Accessibility Survey

City of Downey Myrtle Street - 2nd Street to Firestone Boulevard

Date of Inspection 7/20/2017

Disability Access Consultants

Change in Level North of Firestone Boulevard @ 33.942556669534, - 118.136317580938

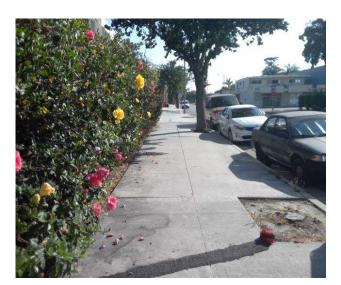
There is a change in elevation greater than recommended value.

On-Site Finding 1.00 inches

Ensure that the change in elevation is within the recommended value.

Recommendation Up to 0.25 inches

Change in Level North of Firestone Boulevard @ 33.942733569146, - 118.136159330606

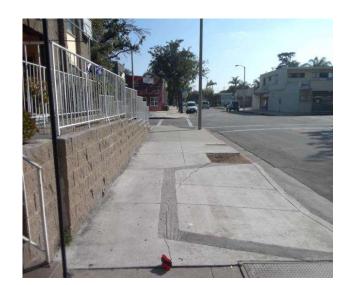
There is a change in elevation greater than recommended value.

On-Site Finding 0.62 inches

Ensure that the change in elevation is within the recommended value.

Recommendation Up to 0.25 inches

Change in Level North of Firestone Boulevard @ 33.942804773918, - 118.136112391949

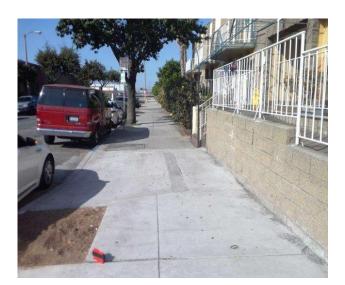
There is a change in elevation greater than recommended value.

On-Site Finding 0.62 inches

Ensure that the change in elevation is within the recommended value.

Recommendation Up to 0.25 inches

West Side North of Firestone Boulevard @ 33.942786972730, - 118.135946094990

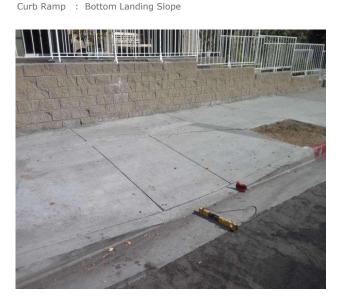
The bottom landing of the curb ramp is on the street, and the slope of the bottom landing is not compliant.

On-Site Finding 12.70 percent

Ensure the bottom landing slope is compliant and provides a smooth transition.

Recommendation Up to 5.00 percent

West Side North of Firestone Boulevard @ 33.942786972730, - 118.135946094990

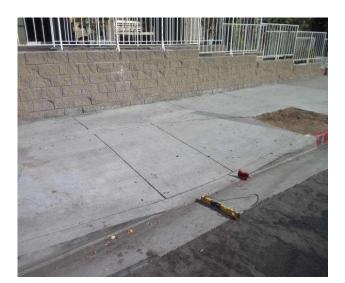
The slope at the top landing is greater than allowed.

On-Site Finding 3.10 percent

Provide a top landing surface that does not exceed the maximum slope and cross slope. Provide a sufficient maneuvering clearance that does not accumulate water.

Recommendation Up to 2.08 percent

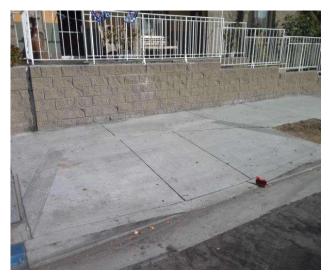
The slope of the curb ramp side flare is greater than allowed.

On-Site Finding 11.10 percent

Provide curb ramp side flares with a compliant slope.

Change in Level South of 2nd Street @ 33.942228458588, -118.136372566223

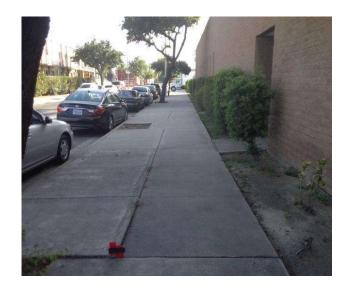
There is a change in elevation greater than recommended value.

On-Site Finding 1.25 inches

Ensure that the change in elevation is within the recommended value.

Change in Level South of 2nd Street @ 33.942228458588, -118.136372566223

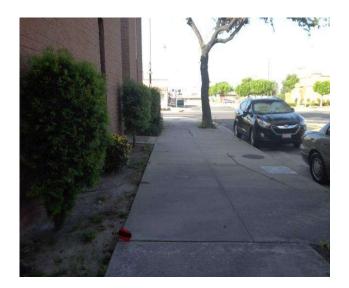
There is a change in elevation greater than recommended value.

On-Site Finding 0.50 inches

Ensure that the change in elevation is within the recommended value.

Change in Level South of 2nd Street @ 33.942383107293, -118.136242479086

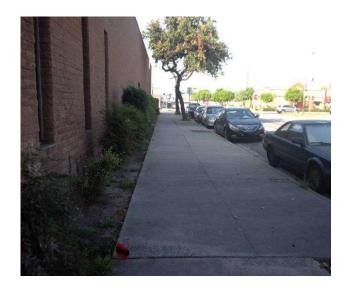
There is a change in elevation greater than recommended value.

On-Site Finding 0.75 inches

Ensure that the change in elevation is within the recommended value.

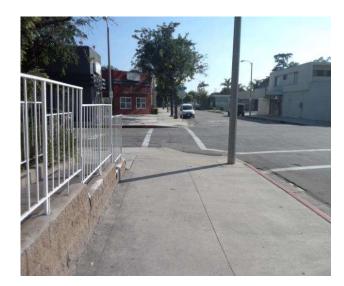
Sidewalk cross slope is not compliant.

On-Site Finding 4.50 percent for 22.00 feet

Repave the sidewalk surface with the recommended cross slope.

Change in Level North of 2nd Street @ 33.943025063303, -118.135952800512

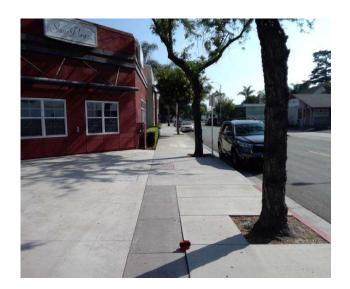
There is a change in elevation greater than recommended value.

On-Site Finding 0.62 inches

Ensure that the change in elevation is within the recommended value.

Change in Level North of 2nd Street @ 33.943238676707, -118.135783821344

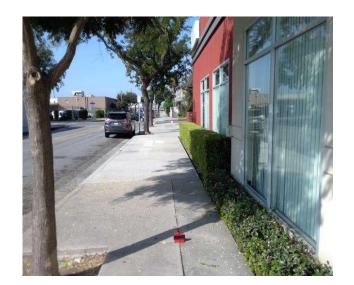
There is a change in elevation greater than recommended value.

On-Site Finding 0.50 inches

Ensure that the change in elevation is within the recommended value.

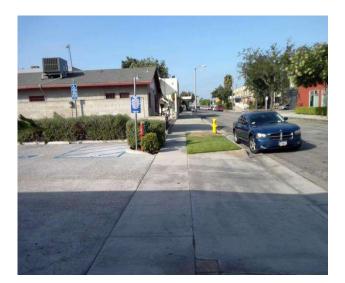
There are no detectable warnings where the pedestrian route crosses vehicular traffic.

On-Site Finding Not Found

Provide detectable warnings.

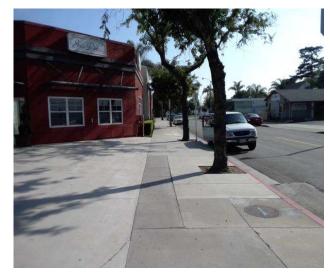
There is no 60X60 turn area at every 200 feet.

On-Site Finding Not Found

Provide a 60X60 turn every 200 feet on the sidewalk.

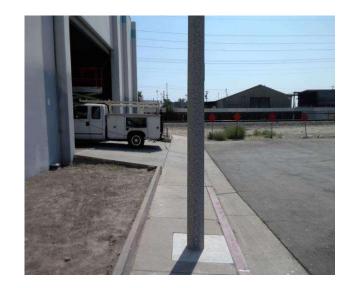
Sidewalk width at the obstruction is not compliant.

On-Site Finding 26.00 inches

Sidewalk width at the obstruction shall have the recommended value.
